**NOTICE
OSHTEMO CHARTER TOWNSHIP
Zoning Board of Appeals**

**Tuesday,
September 22nd, 2015
3:00 p.m.**

6. **Site Plan Review (AutoZone Development, LLC)**
Applicant requests site plan review for a proposed 14,000 square foot retail store on a 1.4 acre parcel—the easternmost unaddressed outlot between Meijer and West Main Street—in the C: Local Business zoning district (Parcel #3905-14-185-039).

7. **Site Plan Review (Architectural Workshop for Kalamazoo Mortgage)**
Applicant requests site plan review for a change in use for the property located at 2425 South 11th Street, currently Pine West Banquet Hall, located in the C: Local Business zoning district (Parcel #3905-25-405-012).

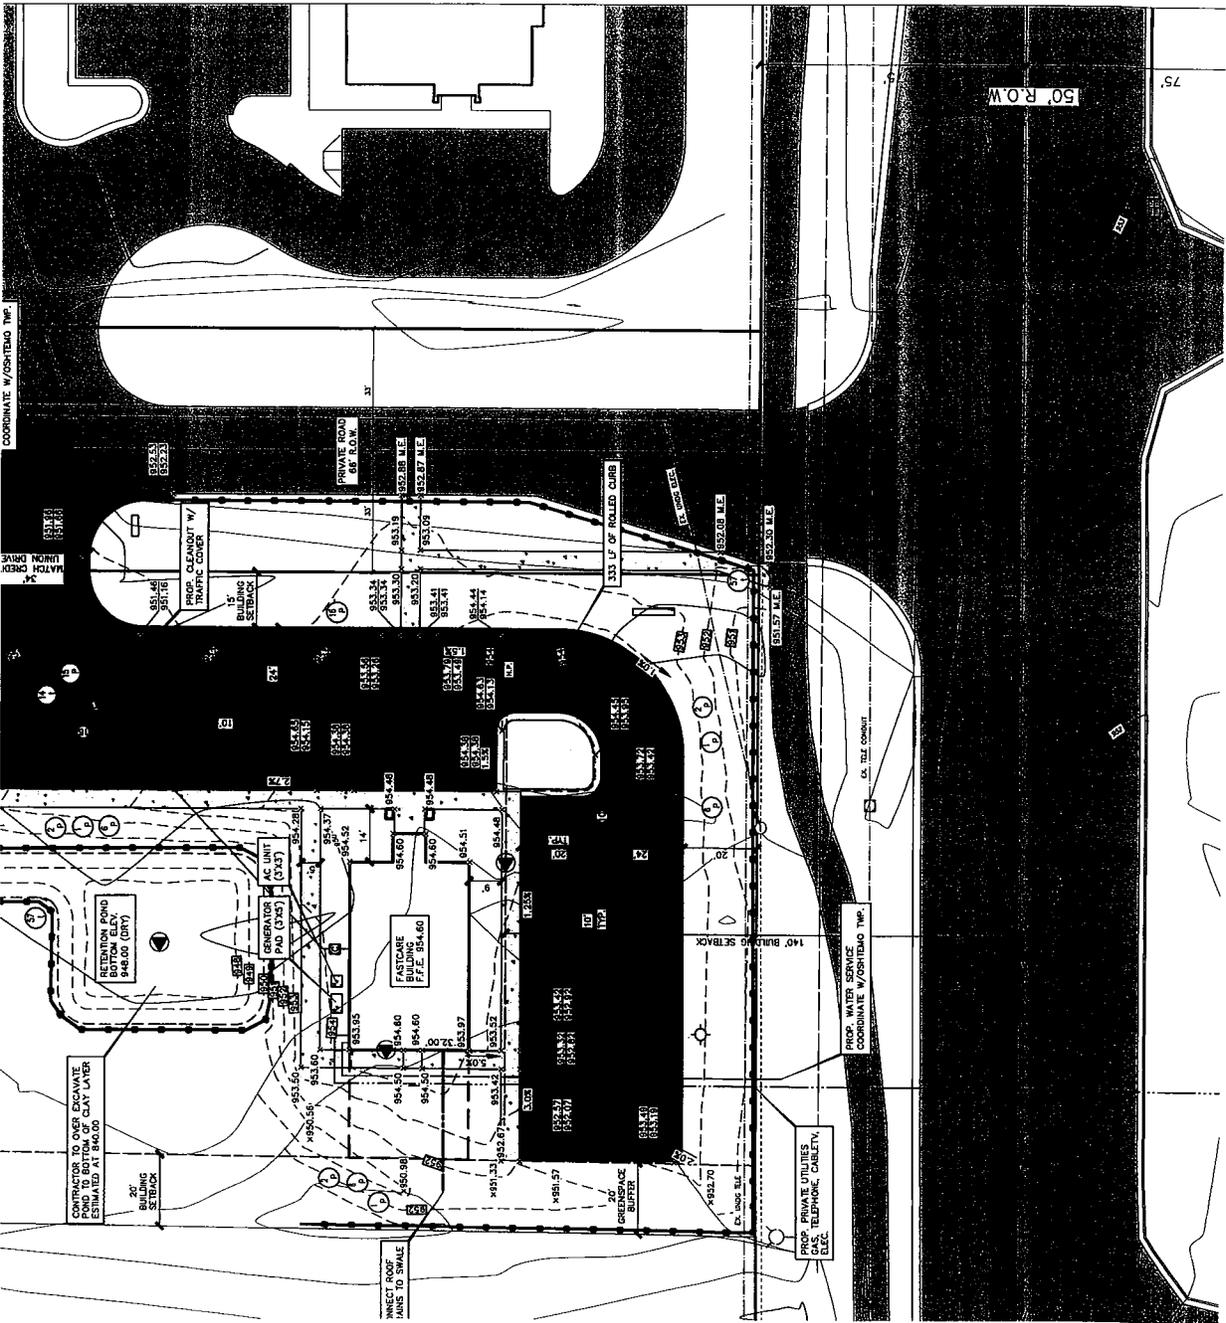
“For the Bronson FastCare in Oshtemo Township we are requesting 26 parking spaces. This was determined based on the historical information we have with our current Bronson FastCare. The Bronson FastCare in Meijer on Westnedge Avenue has seen a year to date average of 24 patients per day. During peak times, which are during flu season and school summer physical season, the average census is higher. Bronson FastCare has seen a high of 61 patients in one day. Patients begin checking in at 8:30 am where there may be a line of 7 to 11 patients for the first hour. There is then a steady stream of 5 to 8 patients per hour. When there is a higher volume of patients we are unable to get them through as quickly and we may have up to 14 patients waiting for care in the practice.

In addition to the patient’s utilizing the parking spaces, staff will also be using the parking lot. There is a minimum of 2 staff members at all times. During our peak seasons we will also have an additional staff person and a manager on-site. If there are vacations, we have staff working split shifts for coverage. For the employee parking there could be a maximum of 6 vehicles at one time in addition to the patient parking.”

In summary Bronson’s current facility on Westnedge at peak times needs 20 spaces (14 patients + 6 staff). The new facility proposed in Oshtemo Township has a larger square footage footprint with a larger waiting room and an additional exam room in comparison to the Westnedge facility and therefore Bronson feels the correct amount of spaces to serve this building is 26.

OSHTEMO FIRE DEPARTMENT SITE PLAN CONCERNS LIST

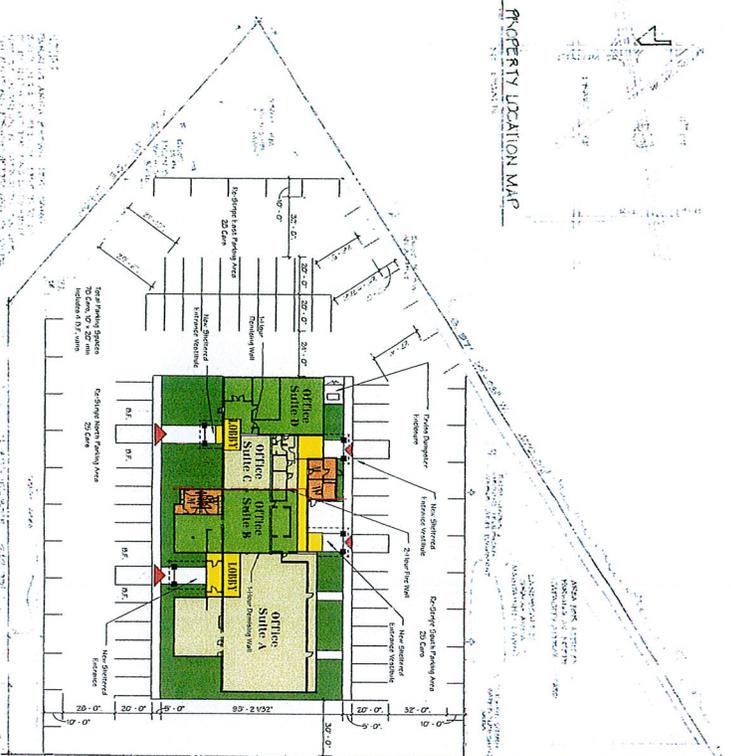
I would recommend the interior parking on the Southeast side be abandoned.
